Interactive comment on “Use of column experiments to investigate the fate of organic micropollutants – a review” by Stefan Banzhaf and Klaus H. Hebig

Stefan Banzhaf and Klaus H. Hebig

Received and published: 12 July 2016

Fig. 1.

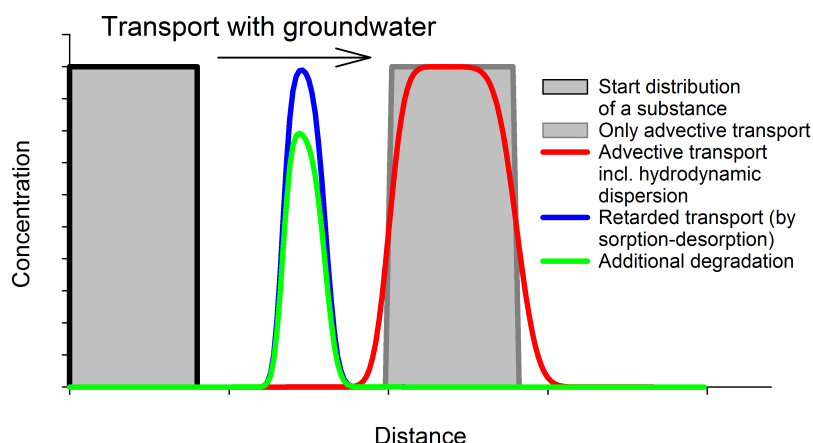
Comment 2: Figure 1 – I would strongly suggest than in place of a cartoon, which it appears the authors have created, that the actual curves be plotted as solutions to the advection dispersion reaction equation. The reason I say this is that I am not convinced that the curves are equally comparable – for example it looks like the red one has undergone less dispersion than the blue, but it is further on in the column, which does not make sense unless you explain differences carefully. The curves as

drawn qualitatively capture the mechanics, but would better convey them if they were also physically consistent with model predictions.

Reply: The curves presented in Figure 1 are indeed modelled using the advection dispersion reaction equation, but are plotted at a constant distance (outlet of the column) and shifted for better illustration of the process. However, a strong retardation can deform the curve in a way that dispersion might look bigger than it actually is (i.e. that it looks as if the red curve has undergone less dispersion than the blue one). This is one reason for applying conservative tracers; since they allow for a separation of this effect. To avoid unclear interpretation of the figure we remodeled the figure and plotted the concentrations at a distinct time point (time step 100). The transport parameters used for the forward modelling of the curves are added to the caption: "Figure 1: Schematic representation of solute transport in groundwater, taking into account the main transport processes of advection, hydrodynamic dispersion, retardation, and degradation. BTCs were modelled using the CXTFIT code (Toride et al., 1999). Model was setup as Deterministic equilibrium CDE with flux-averaged concentration and dimensionless parameters. Characteristic length was set as 100. The initial values are: $v = 1$, $D = 0.1 \cdot 10^{-7}$, $R = 1$, $\mu = 0$ (grey box, only advective transport); $v = 1$, $D = 15$, $R = 1$, $\mu = 0$ (red curve, advective + dispersive transport); $v = 1$, $D = 15$, $R = 3$, $\mu = 0$ (blue curve, retarded transport); $v = 1$, $D = 15$, $R = 3$, $\mu = 0.01$ (green curve additional degradation). Breakthrough was modelled as multiple pulse input with a concentration of $c = 1$ between time step 10 to 50. The position of the curves within the column are plotted for the time step 100. "
